APPENDIX E:
Original Public Comment Letters

RE: Comments on Federal Register: December 12, 2011 (Volume 76, Number 238) [FRC-9505-4]
Clean Water Act Section 303(d): TMDLs for Mercury, Total Dissolved Solids (TDS), Total
Suspended Solids, Sediment, Turbidity, and Fecal Coliform Bacteria for Selected Subsegments in
the Lake Pontchartrain Basin

LDEQ Comments Concerning the following TMDLs submitted to EPA by Tetra Tech:

RE: DRAFT TMDLs for Total Suspended Solids, Sediment, and Turbidity for Selected Subsegments in the Lake Pontchartrain Basin, Louisiana (040301, 040401, and 040903)

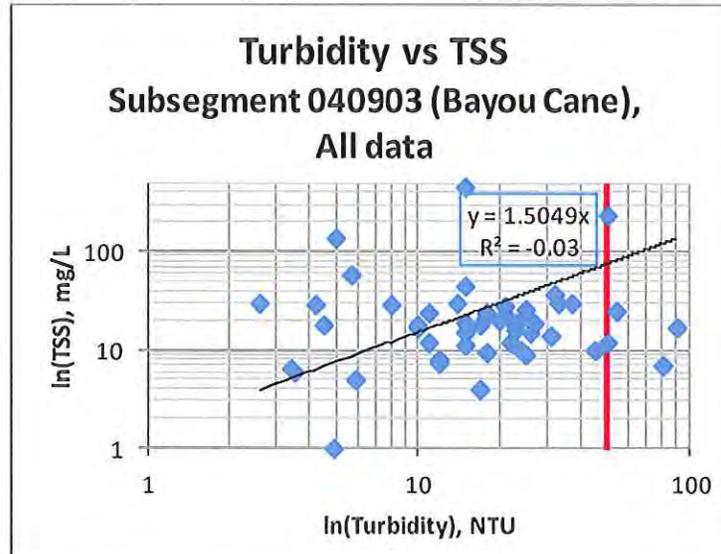
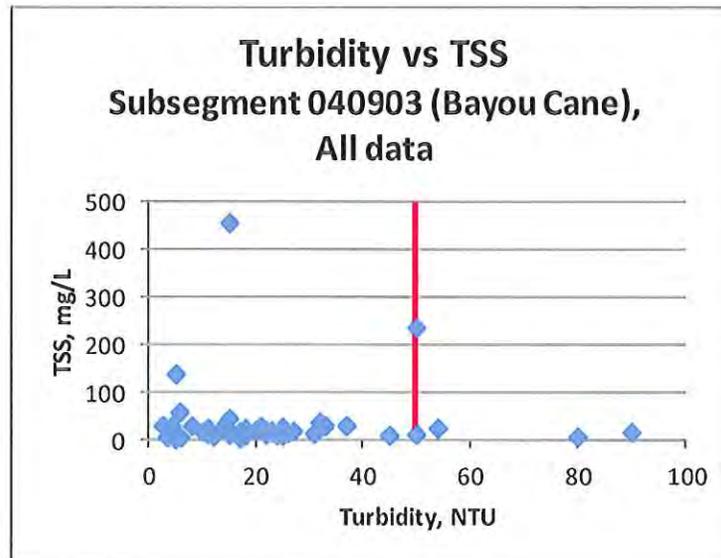
- Utilizing Turbidity as a surrogate for TSS for regulatory purposes without intensive, site specific regression modeling is unsupported.
 - The graphs attached below populated TSS & Turbidity sample results at LDEQ WQ Station 302 for 040903 (Bayou Cane) to demonstrate the lack of correlation between Turbidity & TSS for Subsegment 040903.

- As you can see in the graphs above, only 5 samples out of the total of 53 measured turbidity ≥ 50 NTU. Those samples were measured 1993-2001. TSS values did not exceed 90 mg/L for the largest Turbidity measurement of 90 NTUs.

- This is significantly lower than the 868.07 mg/L assigned by the TMDL.
- Since the failure rate (turbidity ≥ 50 NTU) was 9.4% (5/53) is significantly LESS than the 30% required to be listed on the 305(b) and 303(d) Reports, the waterbody WAS in compliance with its uses and should NOT have been listed on either report.

- There is essentially NO relationship between Turbidity and TSS for subsegment 040903 (Bayou Cane) based upon the data for WQMS 0302 for the period of record 1993 to 2001. Thus, there is NO scientific reason that Turbidity should be utilized as a surrogate for TSS in subsegment 040903. Again, the waterbody should be DELISTED for TSS, Turbidity, & Sediment.
